Alternative Building Configuration

W. Molzon, UCI
mu2e Collaboration Meeting
March 11, 2011

Building Layout

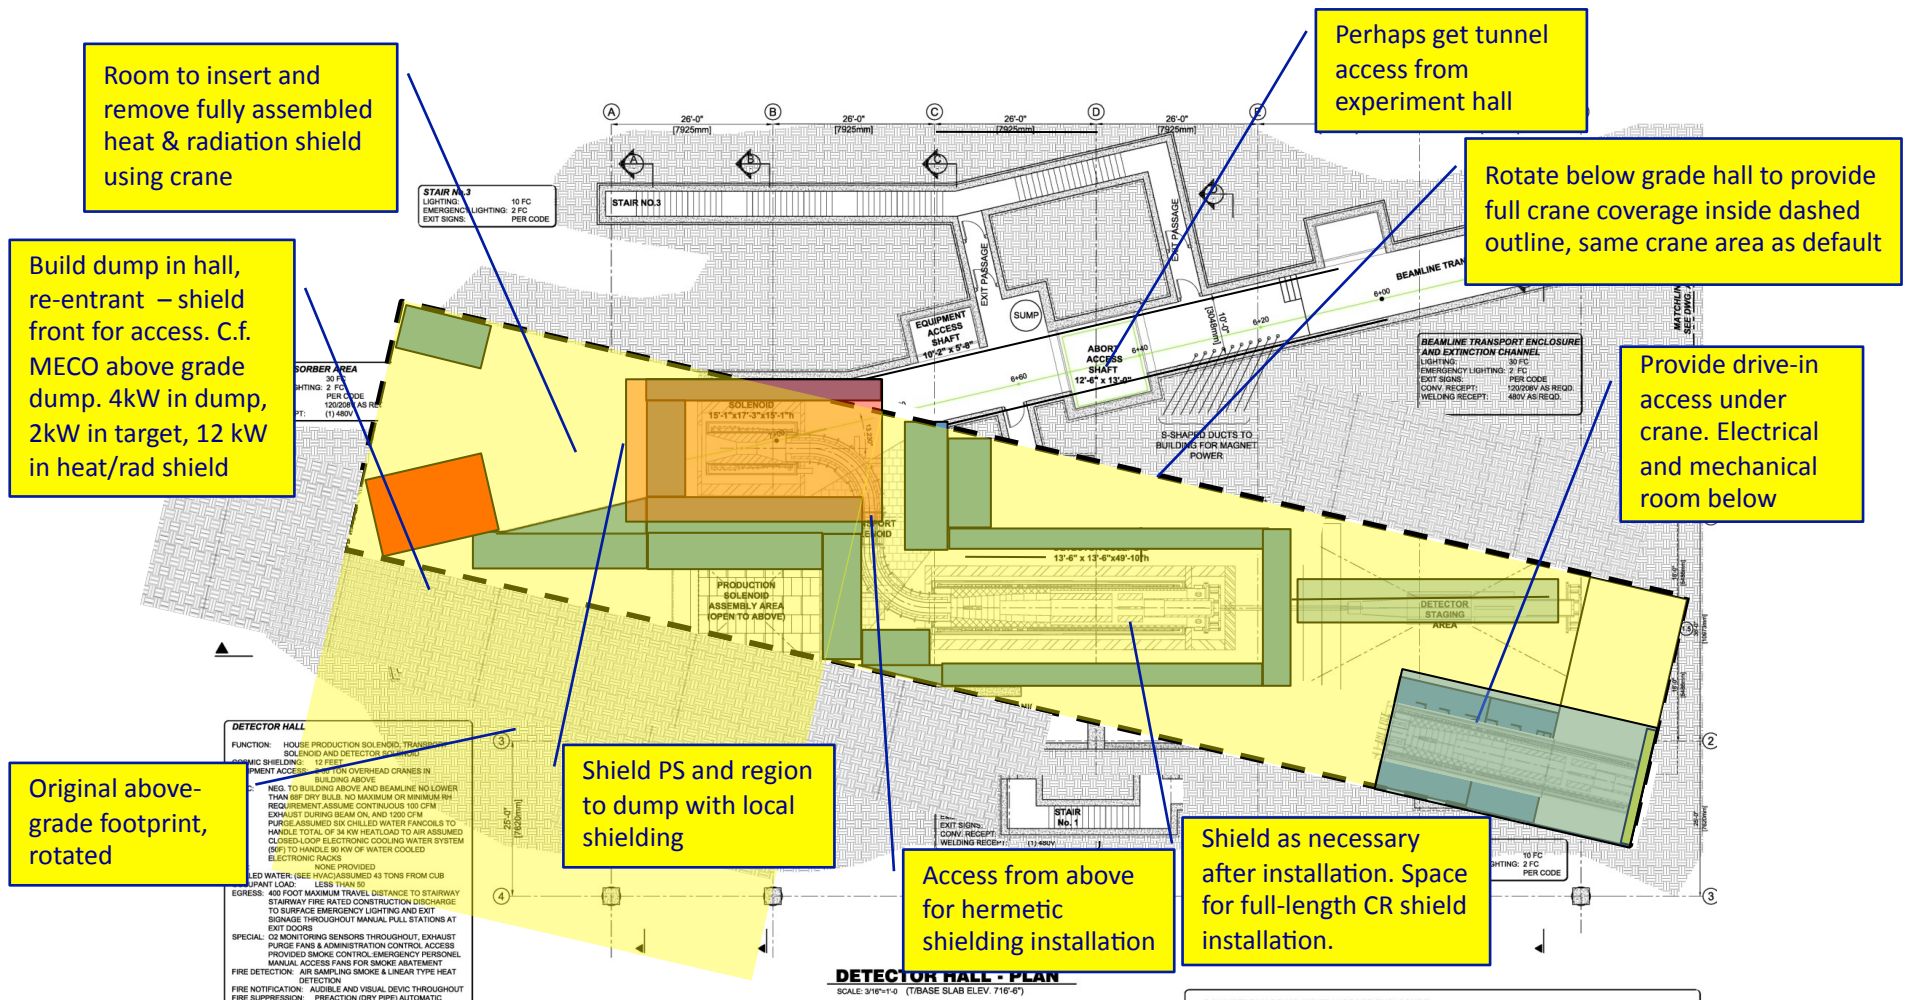
- There is no crane coverage for nearly all of the large elements in the hall: the solenoids, the return yoke steel for the solenoids, and much of the area that must be shielded (for example around the TS).

- Access to the areas around the solenoids is restricted. This may make it difficult to connect cryogenics lines and make other connections.
- It is difficult to access the CR shield detectors, both to install and to repair. It appears that the CR shield detectors cannot be installed as currently designed with full width segments under the PS.

- Installation of shielding, for example around the TS, appears difficult. It must be built up above the TS and below a roof, without crane coverage. Access to thin window for anti-protons will be extremely difficult.

- The building looks expensive. It is perhaps deeper than necessary, more complex installation is required, lack of access from above may be driving use of multiple access stairs, etc. An alternate design would trade some of the costs associated with these features for the cost of movable shielding.

Original elevation

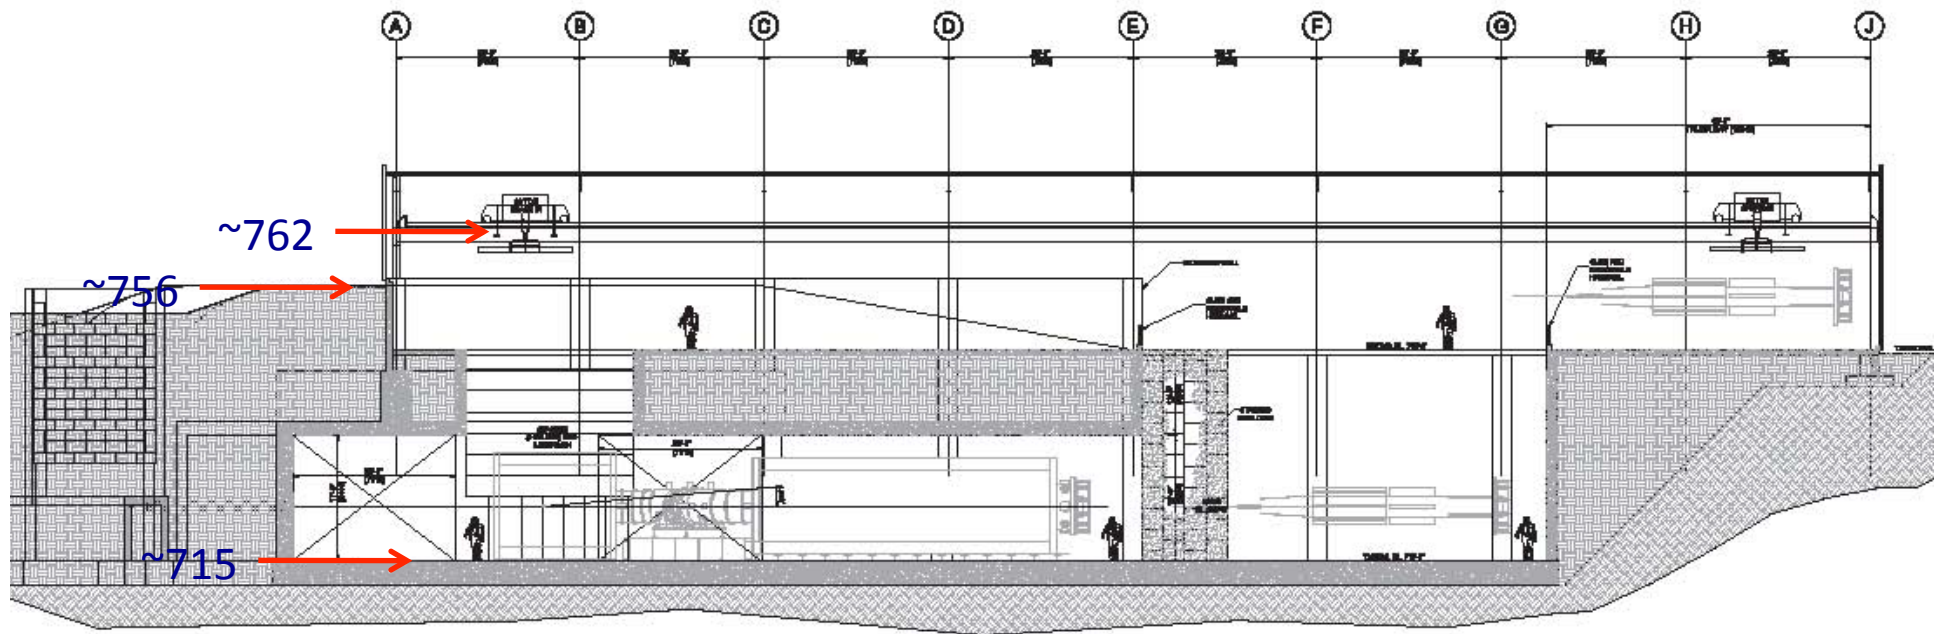
- Raise below grade floor by 7-8 feet
- Proton beam horizontal through the PS
- Room for 21 feet shielding top of PS steel to crane hook height – use some heavy shielding
- Experimental hall could be at the same elevation with no complication, it could also be raised about 7 feet to put it at same level as beam out of debuncher and to save civil construction cost (if it does).
